DrawDiff Comparison Report

Part number: P-001 | Job: 3ee0b4d0-0792-4947-ac7b-f32e4a108eb6 | Generated: 2026-04-30T02:49:38+00:00

SECTION C-C [MATCHED]

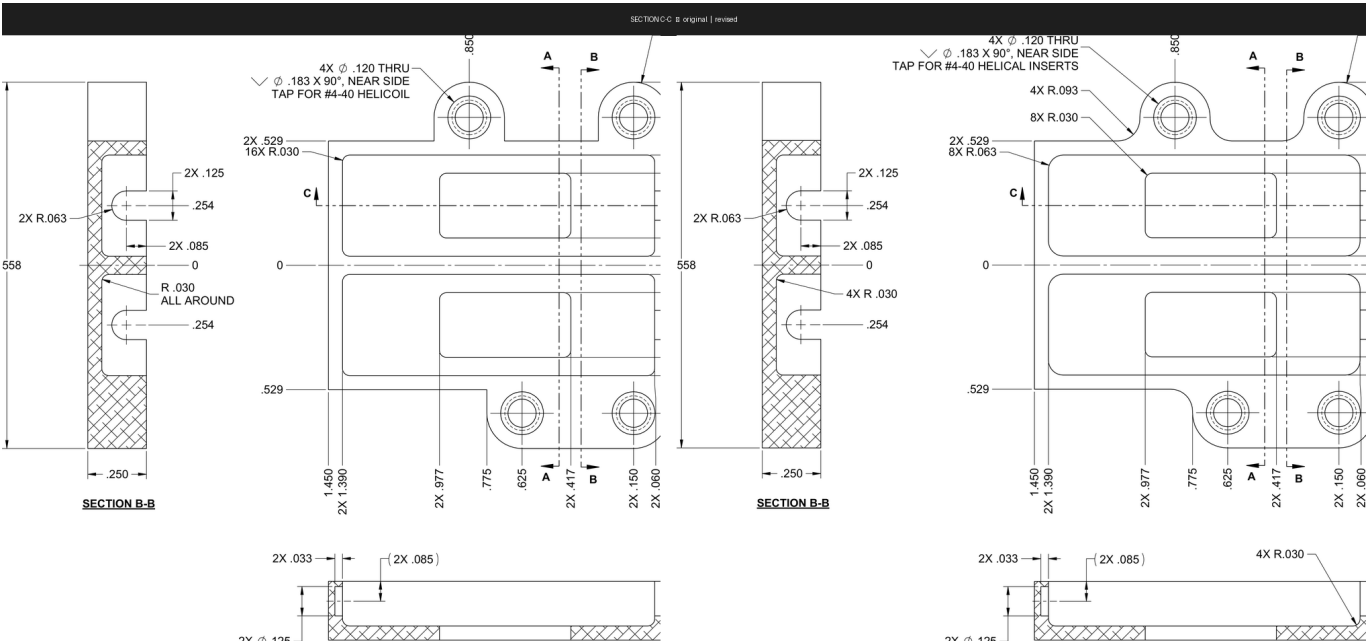
Severity	Field	Original	Revised	Conf.	Rationale
SIGNIFICANT	annotation	16X R.030	8X R.030	0.92	[deduped across views] The quantity multiplier for the R.030 radius on the pocket corners in the front view changed from 16X to 8X, indicating either a reduction in the number of radiused corners or a re-categorization of the

Severity	Field	Original	Revised	Conf.	Rationale
					radii into separate groups, which affects manufacturing instructions.
MINOR	note	TAP FOR #4-40 HELICOIL	TAP FOR #4-40 HELICAL INSERTS	0.95	[deduped across views] The thread insert callout terminology changed from 'HELICOIL' (brand name) to 'HELICAL INSERTS' (generic term), which is a documentation/standardization change but does not alter the functional specification.

ANNOTATION [MATCHED]

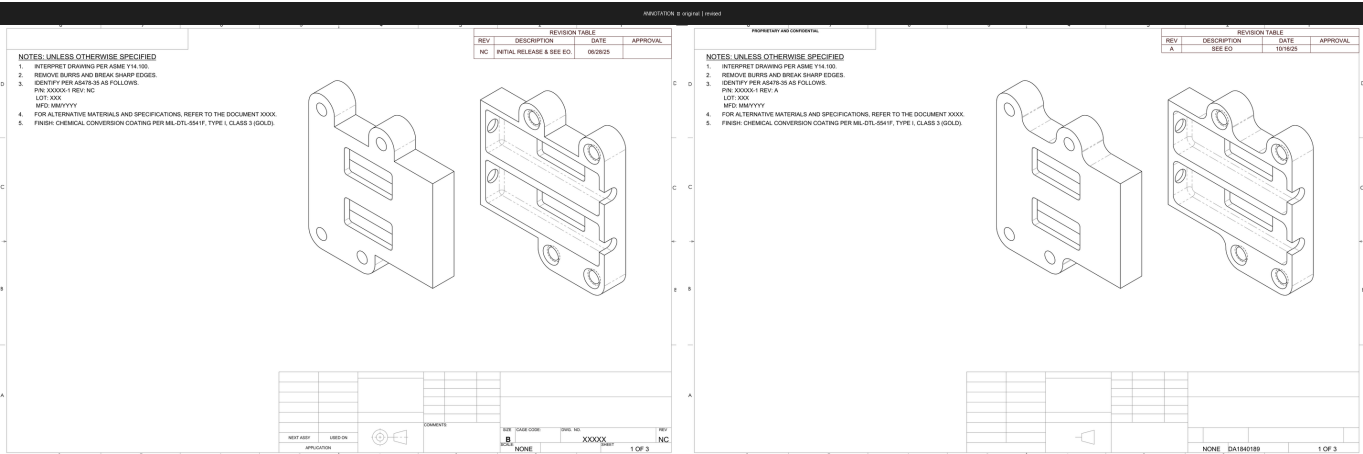
Severity	Field	Original	Revised	Conf.	Rationale
CRITICAL	geometry	Upper-left isometric view shows a rounded top flange/boss feature on the bracket	Upper-left isometric view shows the same bracket but the rounded top flange/boss feature appears removed or modified	0.70	Comparing the left isometric view, the original shows a distinct rounded protrusion/boss at the top of the bracket that appears absent or significantly altered in the revised view, which could affect assembly fit.
SIGNIFICANT	annotation	REV: NC	REV: A	0.95	The part revision level in Note 3 (P/N identification block) has been updated from NC to A, indicating a formal revision increment.

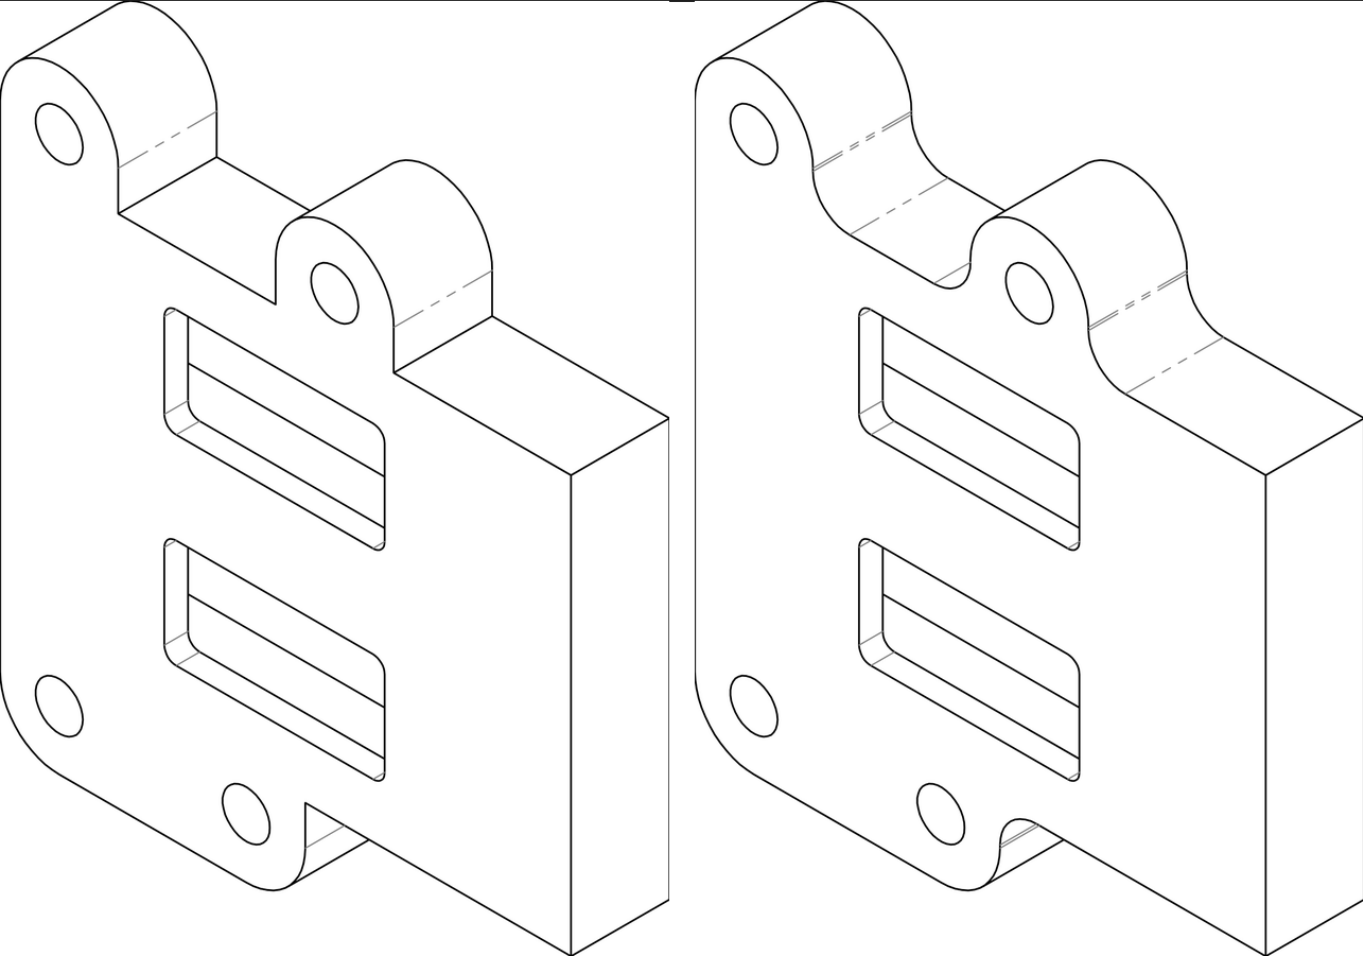
Severity	Field	Original	Revised	Conf.	Rationale
SIGNIFICANT	geometry	Upper flange/boss region shows a single continuous curved profile with one raised arch connecting to the flange, with a relatively thick/solid upper flange section	Upper flange/boss region shows a modified profile with the flange appearing thinner/extended further outward and the arch profile reshaped, with additional curvature detail visible on the left side of the upper flange and a more pronounced undercut or relief between the arch and the flange body	0.72	The upper mounting boss and flange geometry has been revised — the flange appears extended/ thinned and the transition profile between the curved boss and the flat flange has changed shape, which could affect structural stiffness and fit at the mating interface.

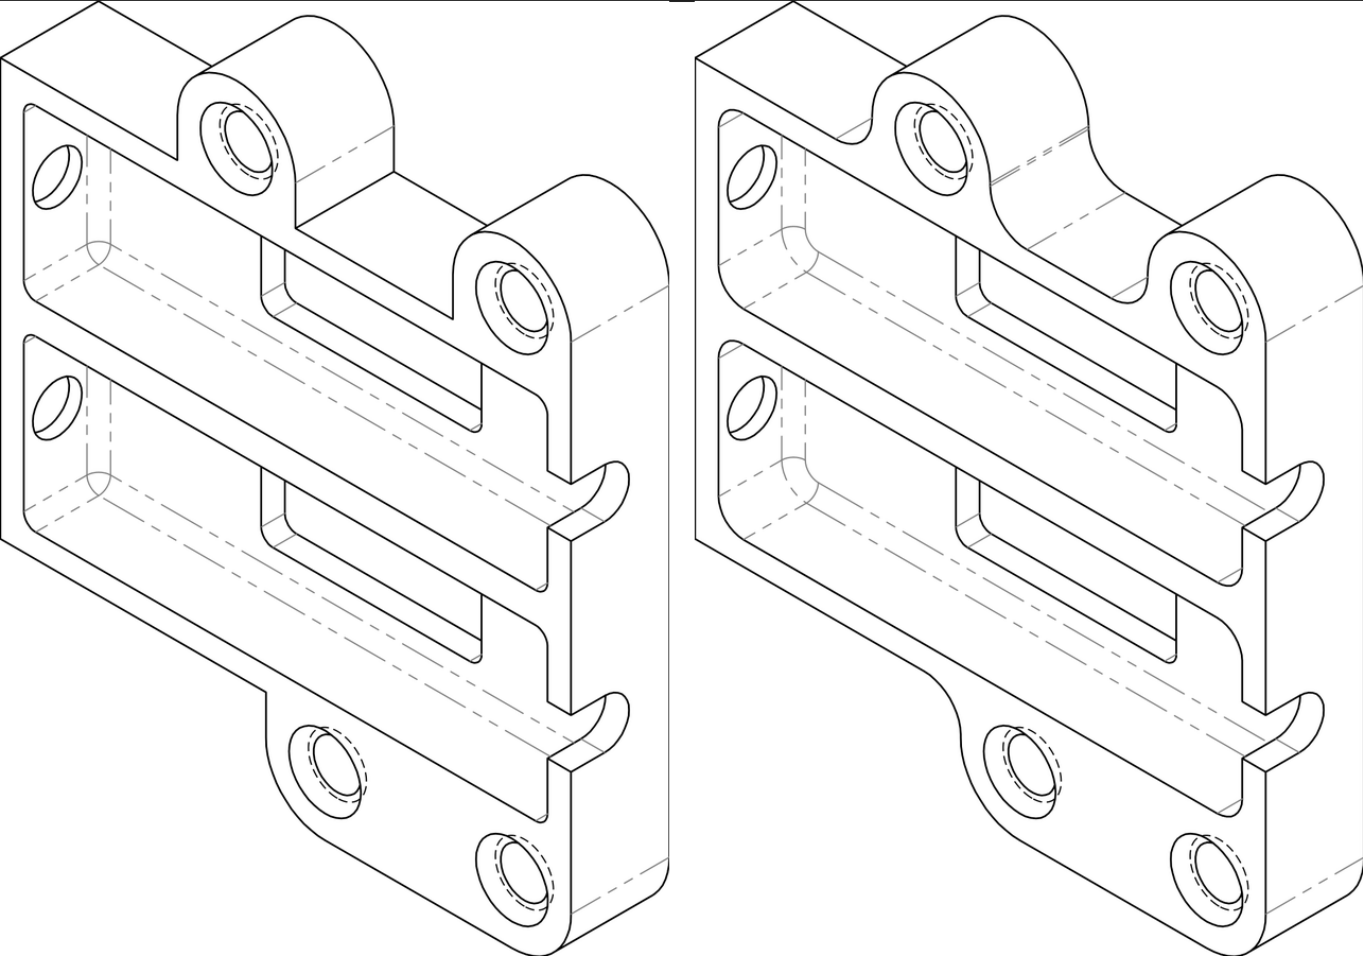
Severity	Field	Original	Revised	Conf.	Rationale
SIGNIFICANT	geometry	Sharp/square interior corners at the left-side pocket/slot transitions (upper and lower left internal corners appear as sharp right-angle intersections)	Filletted/radiused interior corners at the left-side pocket/slot transitions (upper and lower left internal corners now show visible blend radii)	0.72	The internal corners of the rectangular pockets on the left side of the part appear to have had sharp corners replaced with blend radii in the revised view, which affects stress concentration, machinability requirements, and potentially fit with mating components.

SECTION A-A [MATCHED]

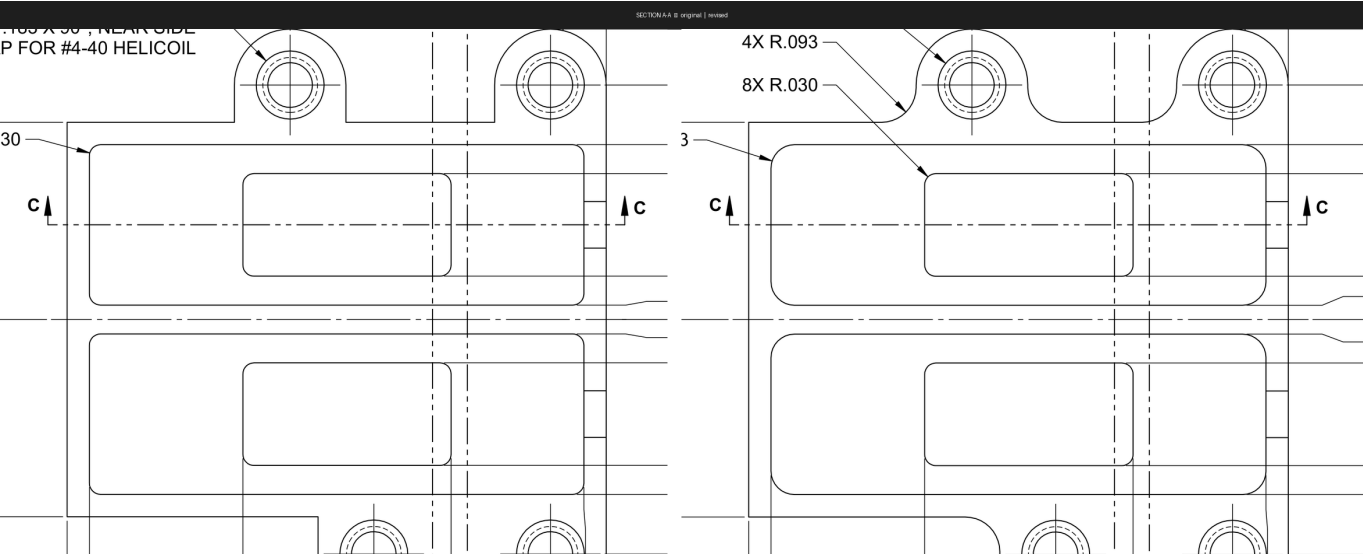
Severity	Field	Original	Revised	Conf.	Rationale
SIGNIFICANT	dimension	—	4X R.093	0.90	A new radius callout '4X R.093' has been added to the mounting boss features, specifying fillet radii that were previously undefined in this view.
SIGNIFICANT	geometry	Sharp/small radius corners on upper pocket and lower pocket edges	Larger visible radii on pocket corners	0.72	The pocket corners in the revised view appear to have noticeably larger radii compared to the original, consistent with the newly added radius callouts and potentially affecting tool path and fit.
UNCERTAIN	callout	.165 X 90°, NEAR SIDE TAP FOR #4-40 HELICOIL	—	0.55	The helicoil tap note visible in the original upper-left corner appears to have been repositioned or is cropped differently in the revised view; the text is partially cut off in both but the visible portion differs.

SECTION A-A [MATCHED]

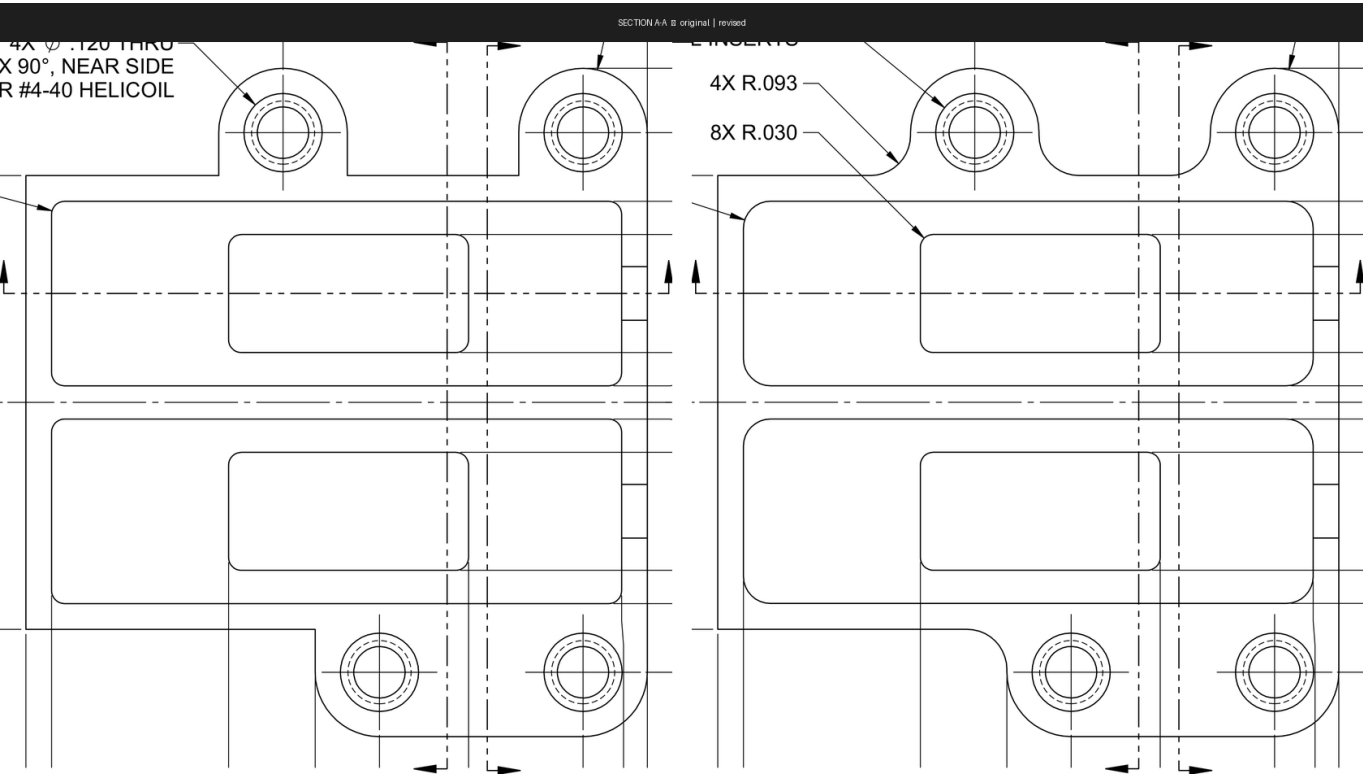
Severity	Field	Original	Revised	Conf.	Rationale
SIGNIFICANT	annotation	—	4X R.093	0.92	[deduped across views] A new radius callout '4X R.093' has been added in the revised view, specifying four corner radii that were not explicitly called out in the original, which affects machining requirements for the boss/pocket corners.
SIGNIFICANT	note	4X Ø .120 THRU X 90°, NEAR SIDE R #4-40 HELICOIL	E INSERTS (partial, truncated at top)	0.72	The hole and helicoil callout text visible in the original ('4X Ø .120 THRU ... #4-40 HELICOIL') appears to have been revised or reformatted in the revised view where only a partial truncated note 'E INSERTS' is visible, suggesting the callout wording or format has changed.

SECTION A-A [MATCHED]

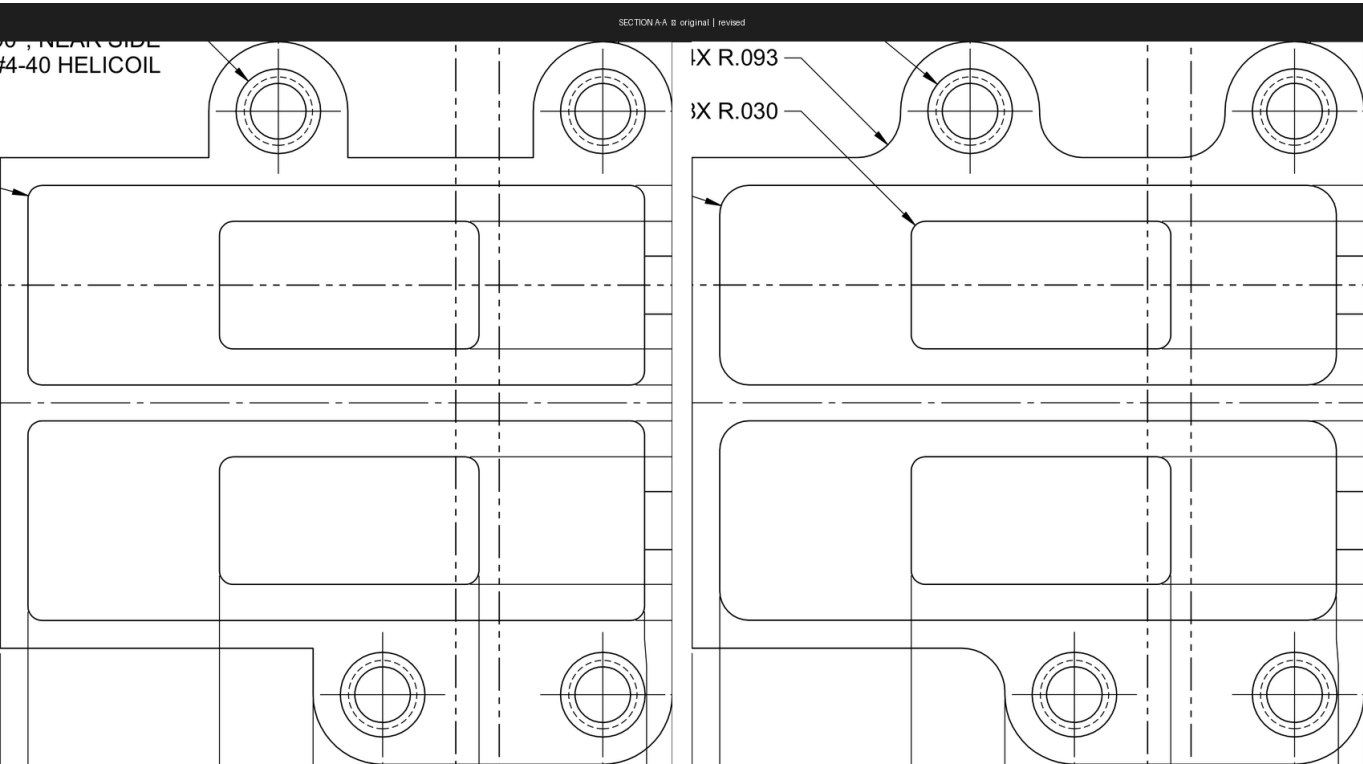
Severity	Field	Original	Revised	Conf.	Rationale
SIGNIFICANT	geometry	Mounting boss profile shown with sharp/undefined blend between boss and top flange	Mounting boss profile shown with smooth continuous fillet blending into top flange	0.75	The revised view shows a smoother, more clearly defined fillet geometry at the base of the mounting bosses compared to the original, consistent with the newly added R.093 callout defining that blend radius.
MINOR	note	NEAR SIDE (partial text visible at top)	—	0.72	The partial 'NEAR SIDE' note visible in the upper-left of the original view is no longer present in the revised view, suggesting a note or label was removed or relocated.

SECTION A-A [MATCHED]

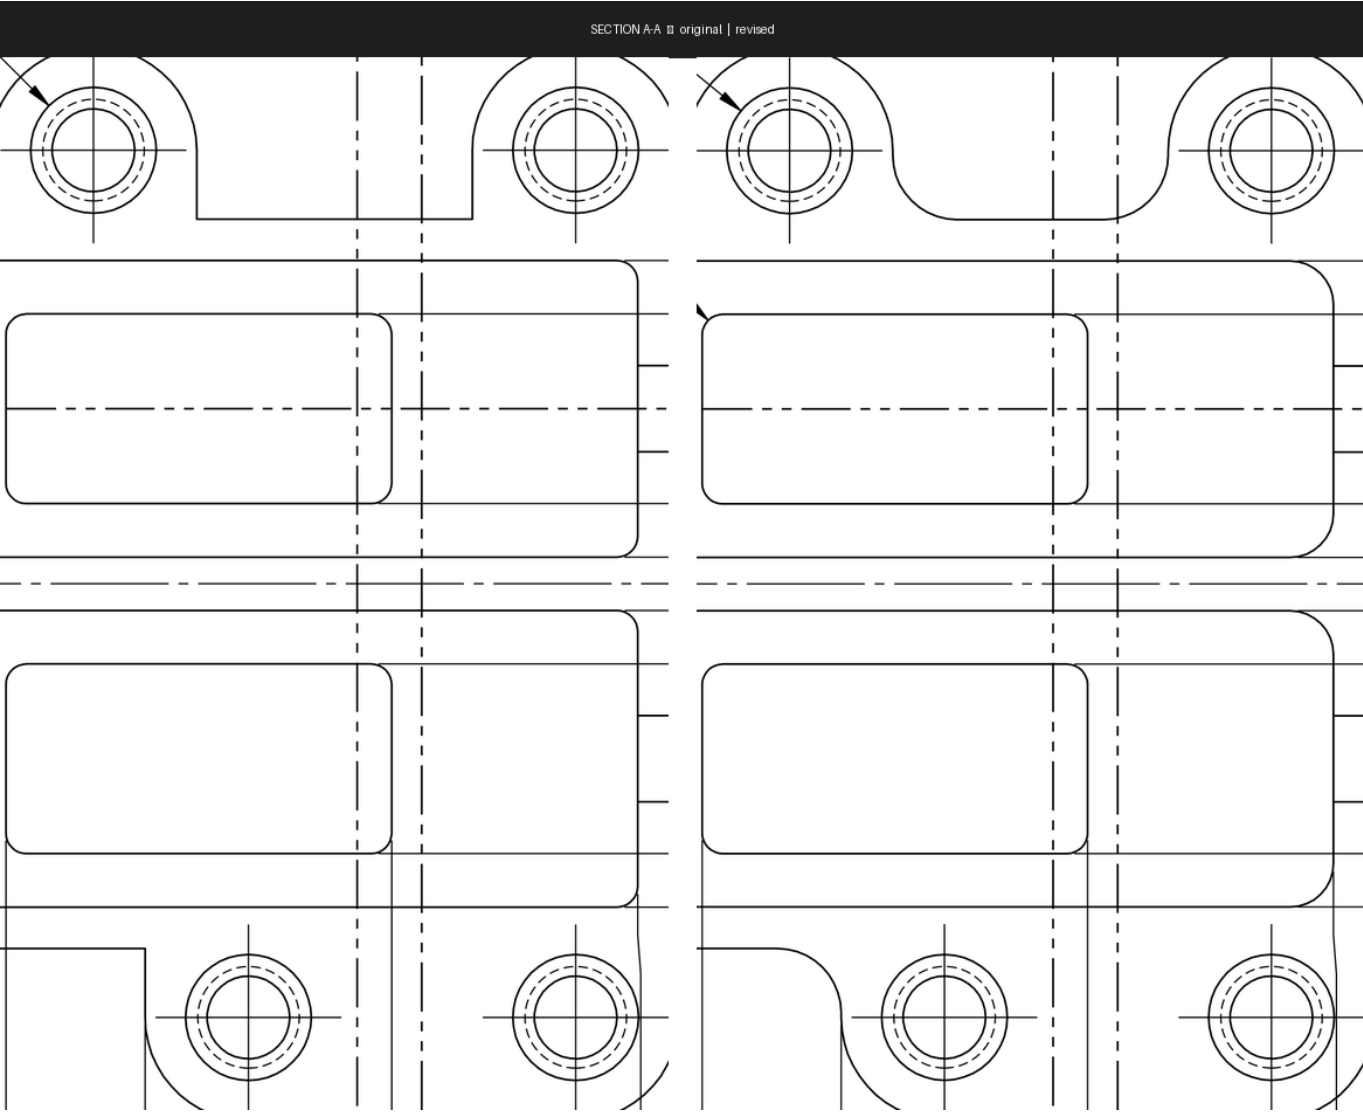
Severity	Field	Original	Revised	Conf.	Rationale
SIGNIFICANT	geometry	Sharp/straight corner transition between mounting boss base and main body (top region, left and right sides)	Radiused/filletted corner transition between boss base and main body (top region, left and right sides)	0.82	The original shows a sharp step-down from the mounting boss flanges to the main body surface, while the revised view shows a smooth curved fillet at those transitions, indicating a geometry change to the boss root radii that affects stress concentration and machinability.
MINOR	annotation	Leader arrow pointing to upper-left mounting boss circle (top of view)	Leader arrow repositioned or pointing to left pocket upper-left corner area (mid-left of view)	0.65	A small leader arrow visible in the upper-left of the original appears to have moved or a second arrow appears near the upper-left of the pocket region in the revised view, suggesting a callout was repositioned or reassigned.

SECTION B-B [ADDED]

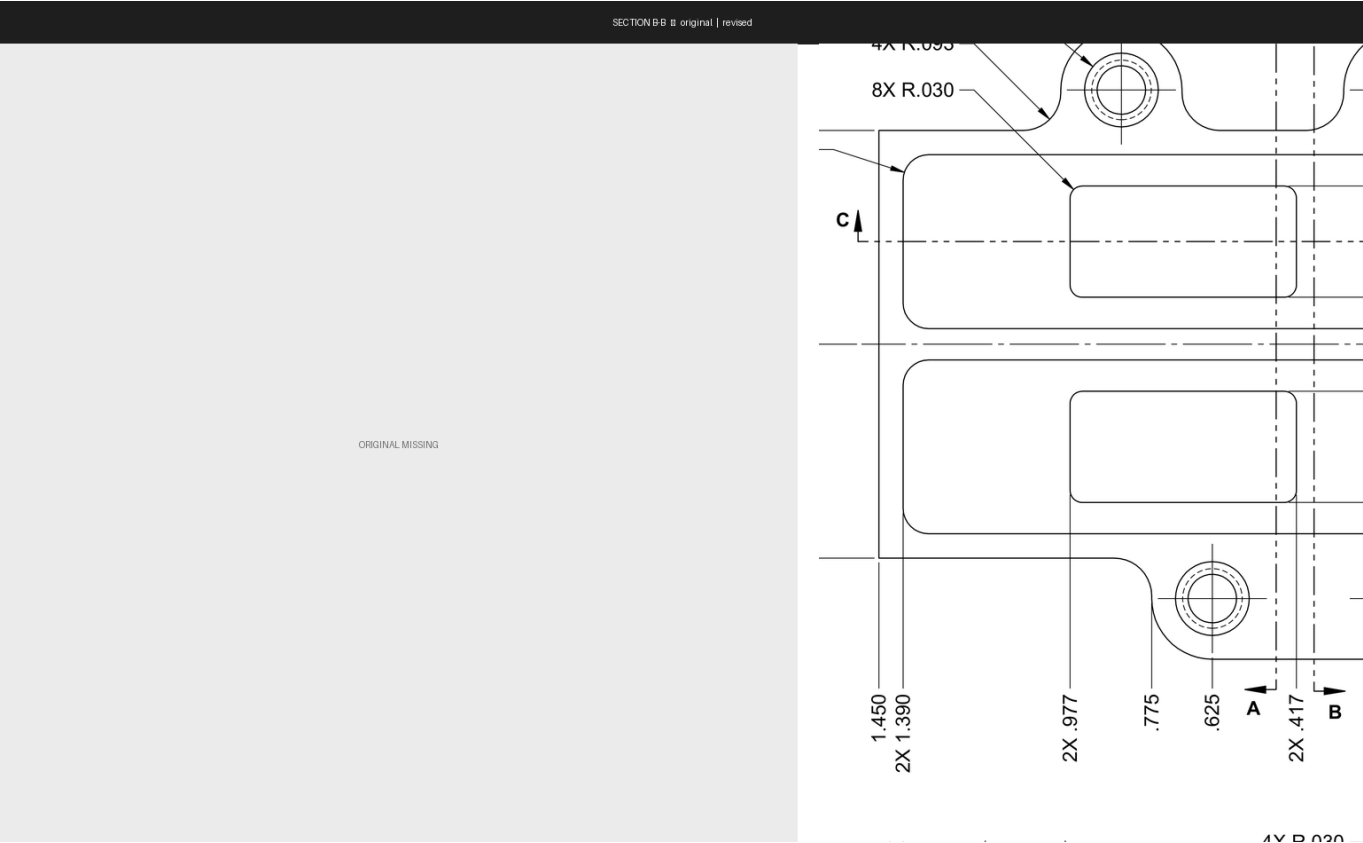
Severity	Field	Original	Revised	Conf.	Rationale
SIGNIFICANT	view	—	SECTION B-B	1.00	View 'SECTION B-B' appears only in the revised drawing.
